**PURCHASER REQUEST FOR EXTRAS**

103. No. 7
King Ridge

Lot No.	70	Horse Type	Carroll	Elevation	4	Date Required		Date Ordered	
---------	----	------------	---------	-----------	---	---------------	--	--------------	--

CORRALERO

Basement Floor Elev. 'A'

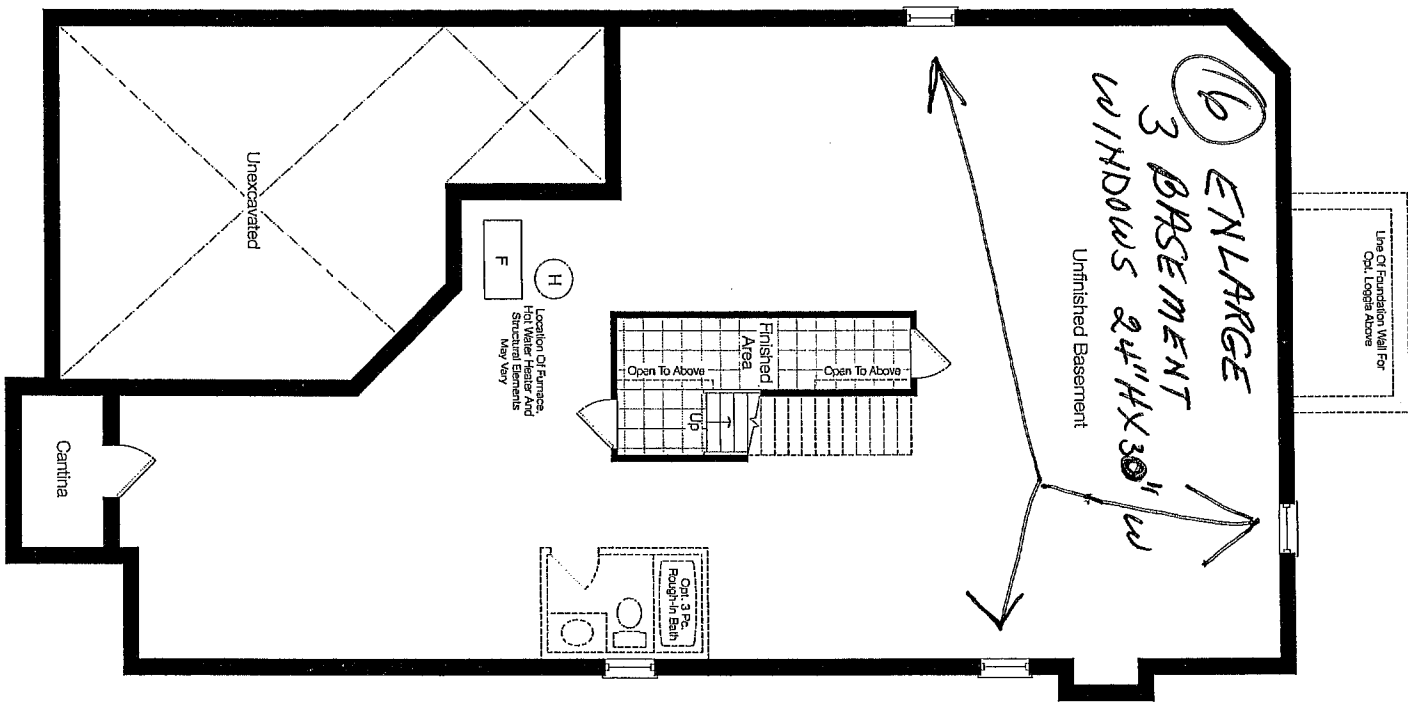
"OFFICE USE ONLY"	ITEM	DESCRIPTION	PRICE
	(6)	Cmlawa 3 Basement windows 24"H X 30"W	[REDACTED]
		SUB-TOTAL	
		HST	
		TOTAL AMOUNT ▶
